**AMENDMENT NO. 3 TO PLANNED UNIT DEVELOPMENT NO. 83**

RE: Administrative Amendment to PUD No. 83 (Amendment No. 3)

Further to your request for administrative modifications of Planned Unit Development (PUD) No. 83 (University Village), the following changes to the Development Plan are hereby approved according to the provisions of Section 16.1 of the PUD:

EXHIBIT A

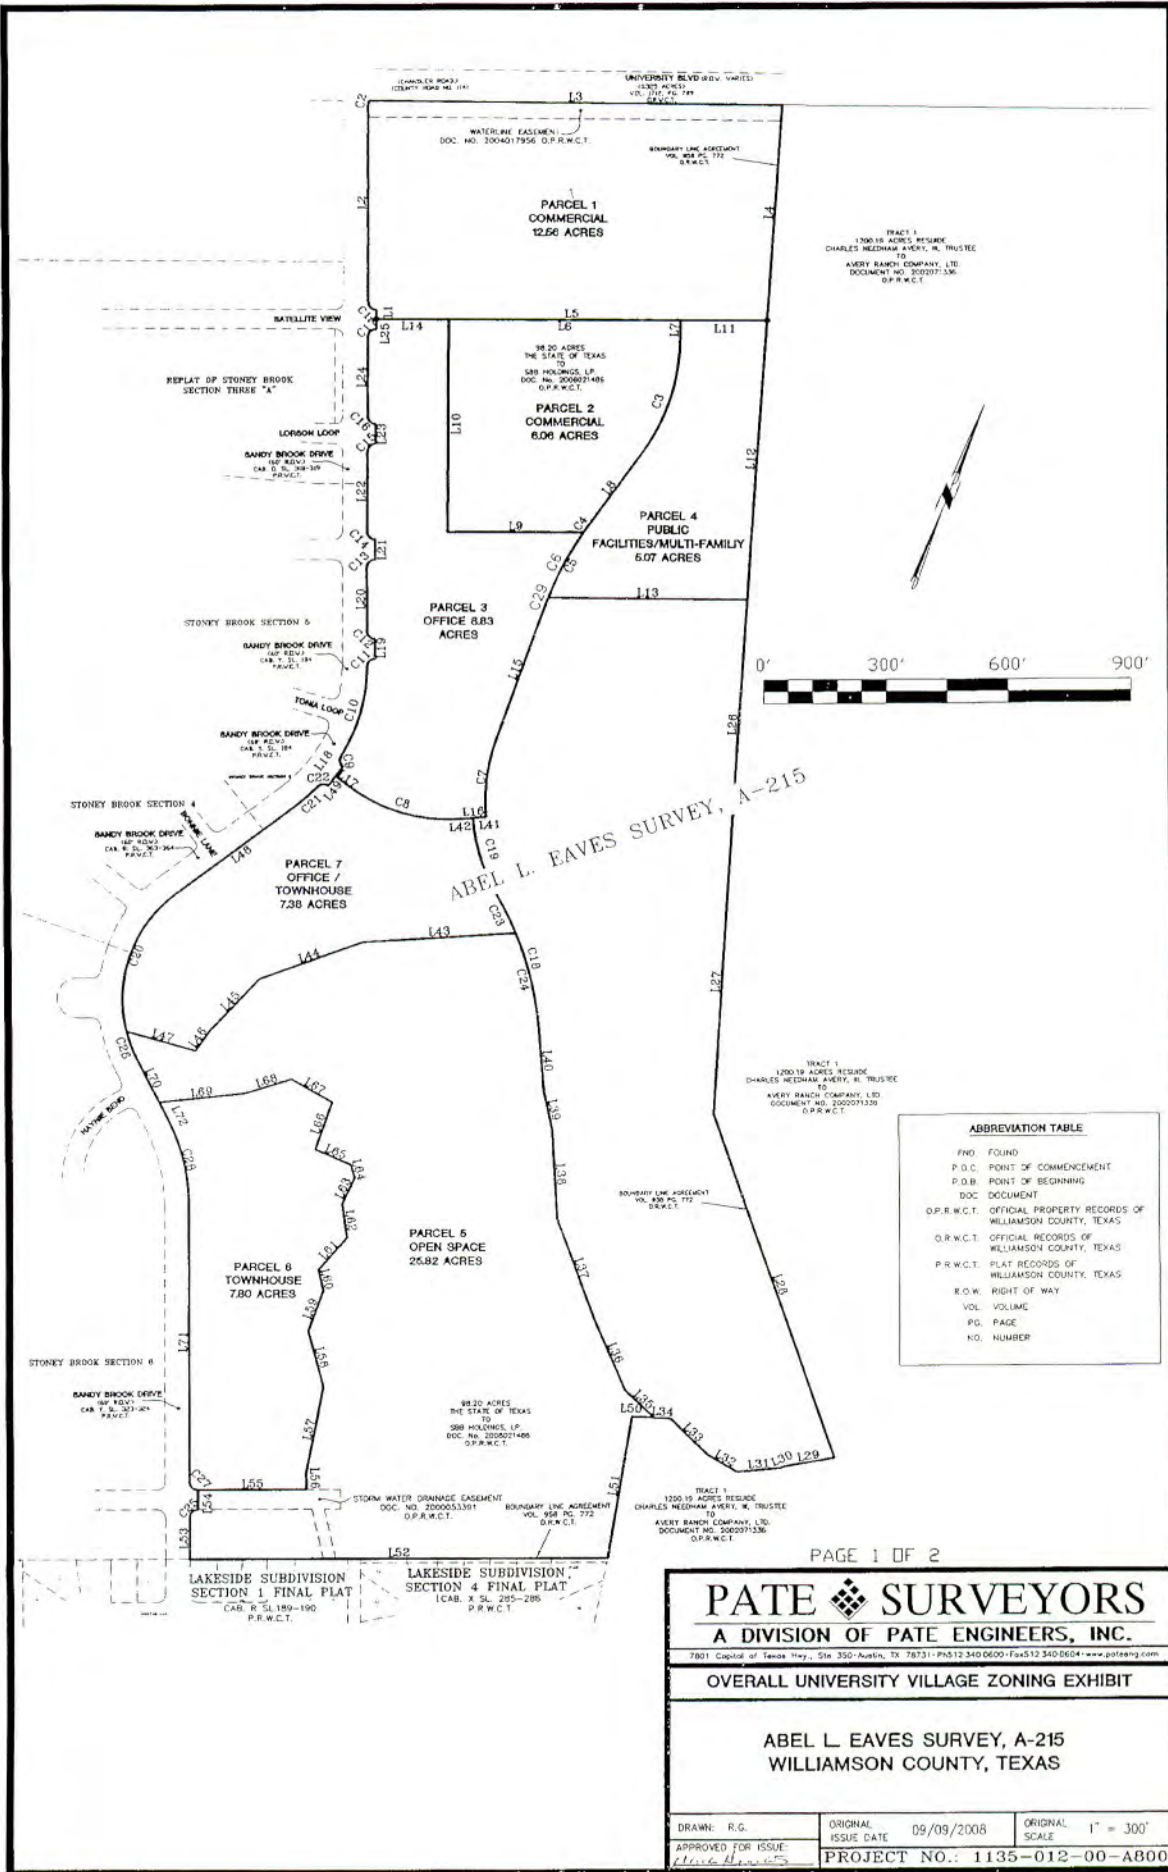
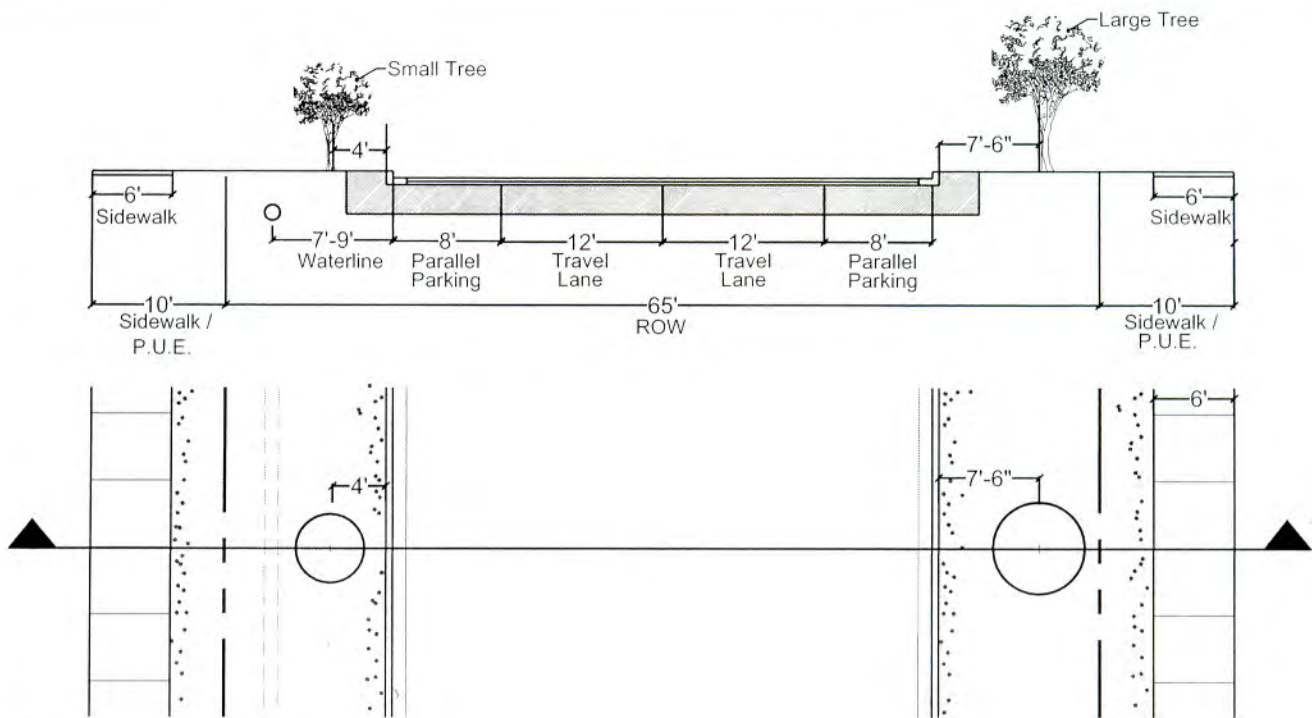
- **II, 2. - Property** shall read as follows:

This Plan includes approximately 73.60 acres of land generally located at the southeast corner of University Boulevard and Sandy Brook Drive, within the city limits of Round Rock, Texas, and more particularly described in **Exhibit A**.

① Campus Village Drive  
North of Satellite View

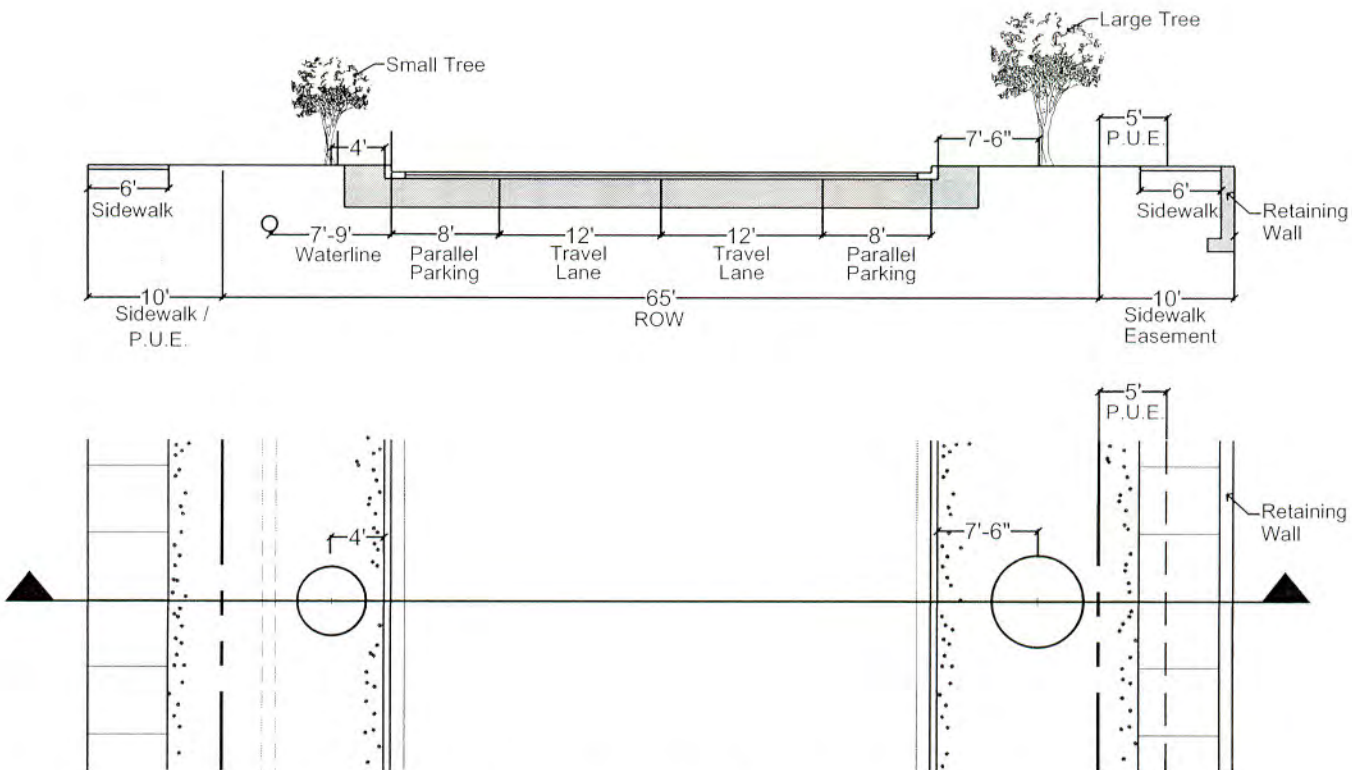
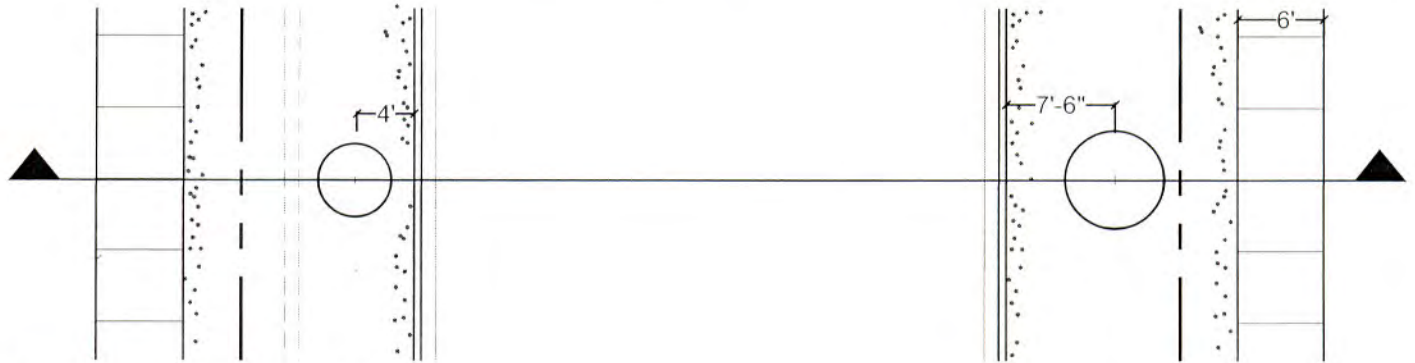
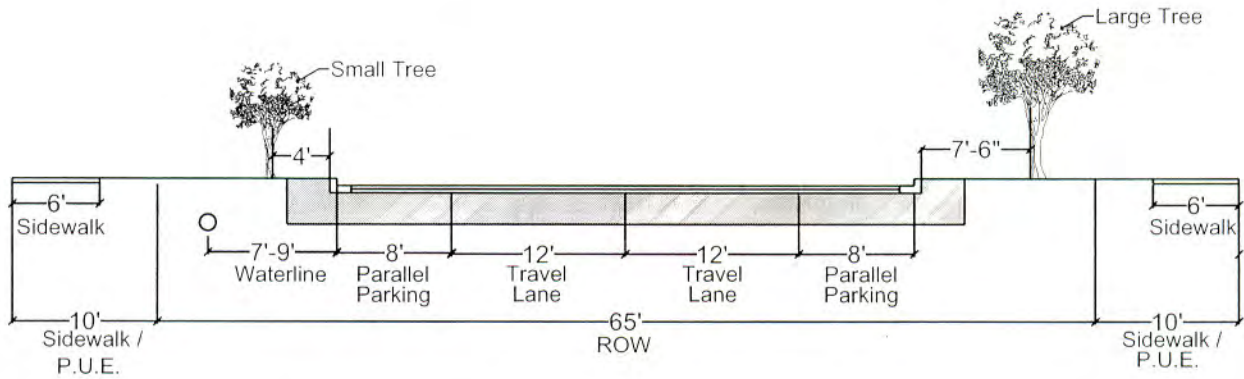
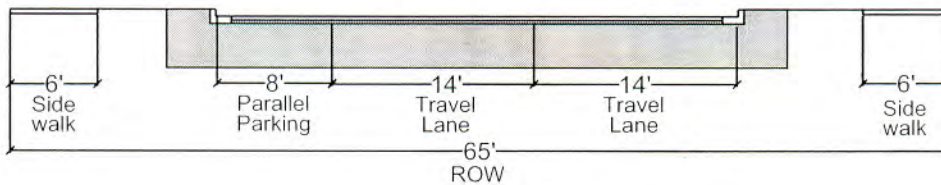
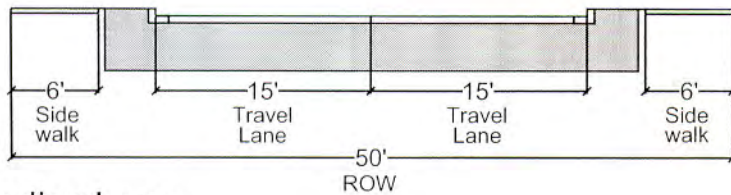
Within the right of way of University Village Drive (Campus Village Drive), street trees shall be planted as described below and in **Exhibit E**:

- (i) On the east side of Campus Village Drive, Live Oak trees with a minimum of a 3-inch caliper measured at six inches (6”) above base shall be planted at a spacing of not greater than forty feet (40’);
- (ii) On the west side of Campus Village Drive, Small Trees with a minimum of a one and one-half inch (1.5”) caliper for a single trunk measured at six inches (6”) above base and a minimum height of six feet (6’) shall be planted at a spacing of not greater than twenty feet (20’), except where placement conflicts with driveways and site distances, as approved by the City.
- (iii) Trees shall consist of a minimum of 75% evergreen species.
- (iv) Live Oak Trees shall be planted with the development of the adjacent tracts of land and shall be credited toward the Street Yard Tree requirement in Section 46-195 (b) (3) of the Code.

- **Exhibit 'E' - Street Sections** is deleted and replaced with the attached Exhibit 'E'.
- **Exhibit 'G' - Park Amenity Trail** is deleted and replaced with the attached Exhibit 'G'.

EXHIBIT G  
UNIVERSITY VILLAGE  
PARK AMENITY TRAIL

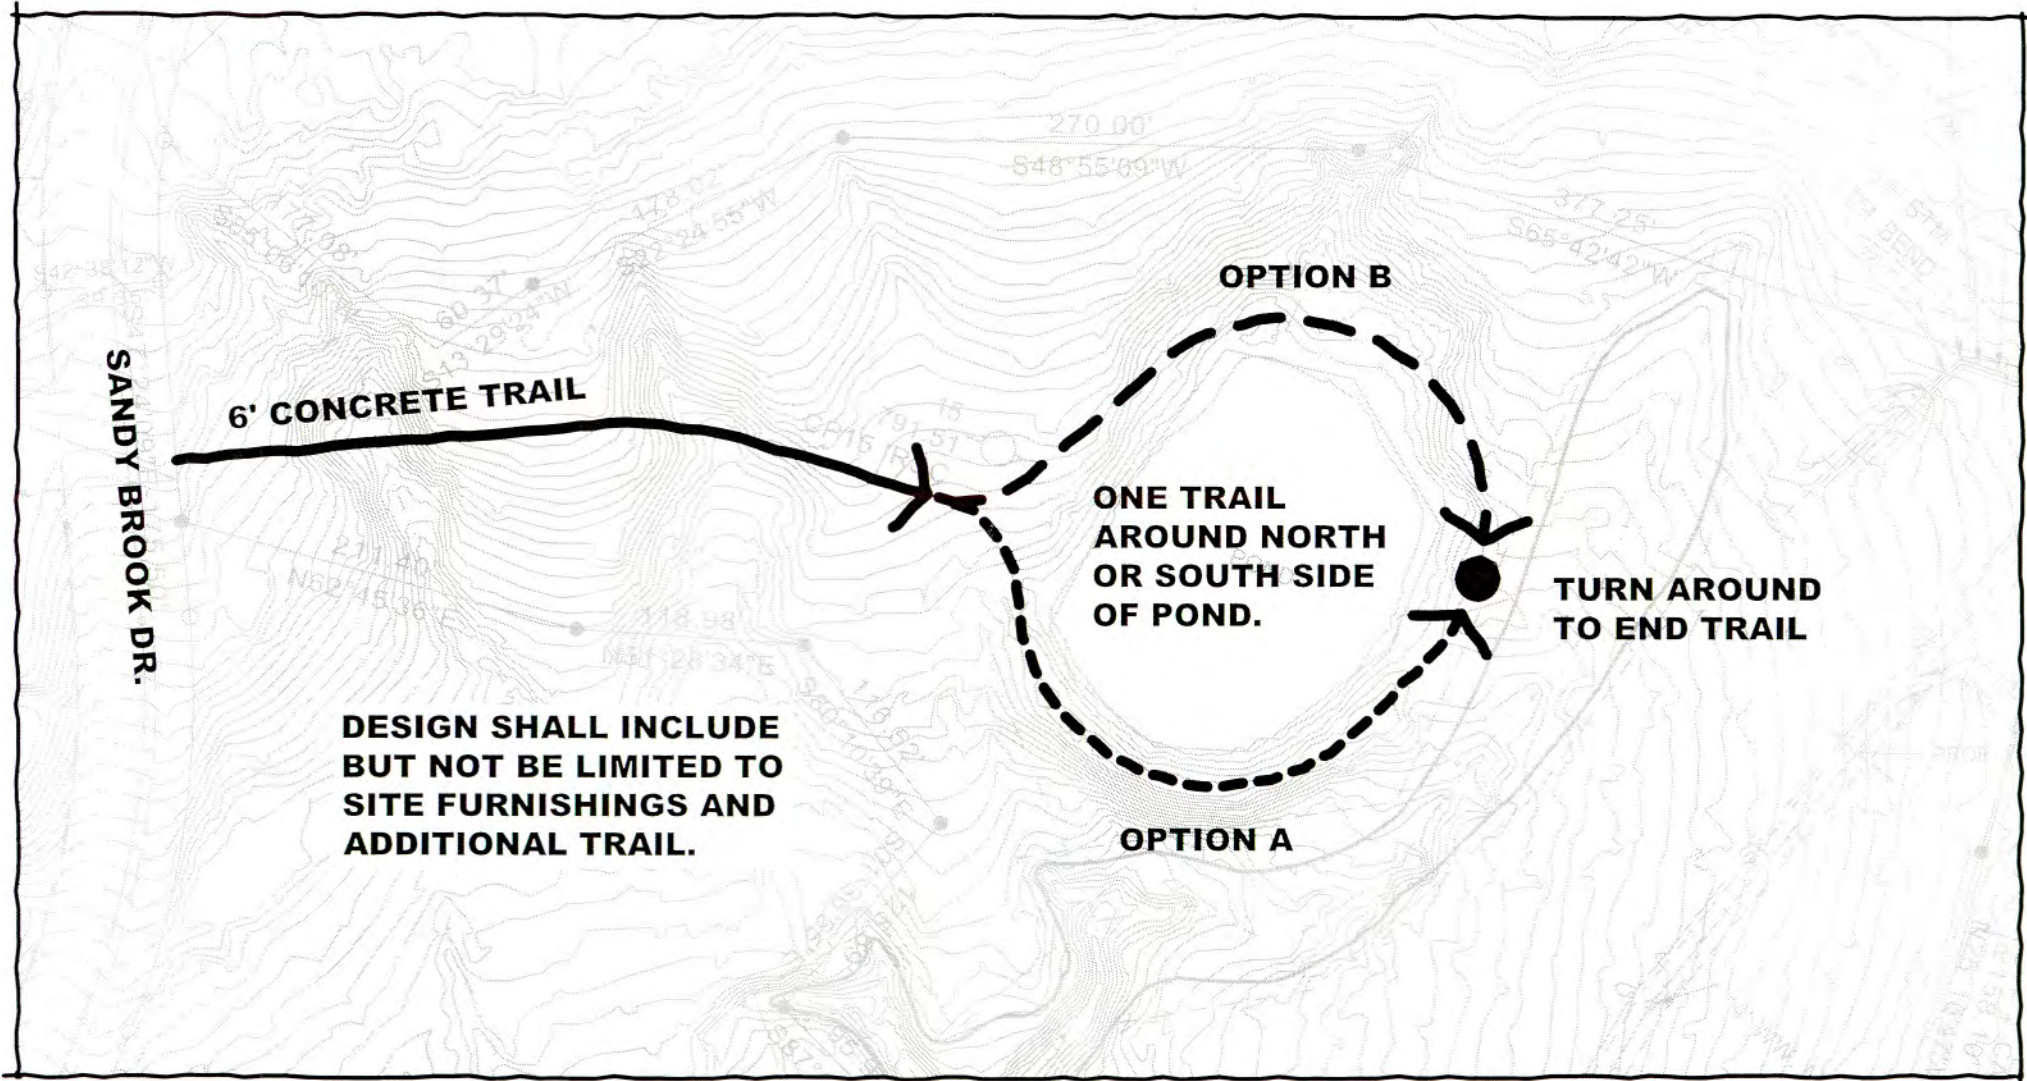
13.3 The Owner shall construct a hike and bike trail from Sandy Brook Drive to the eastern side of the existing pond located on the northern portion of Parcel 5, as shown on **Exhibit G**. The Owner shall also install additional park amenities including but not limited to; benches, picnic tables, additional trail and trees along the trail and adjacent to the pond. Trail location, alignment and additional park amenities shall be approved in writing by the Director of Parks and Recreation prior to construction of the park. The trail shall comply with the American with Disabilities Act Accessibility Guidelines (ADAAG) and the standards set forth in the Texas Architectural Barriers Act (TAS).
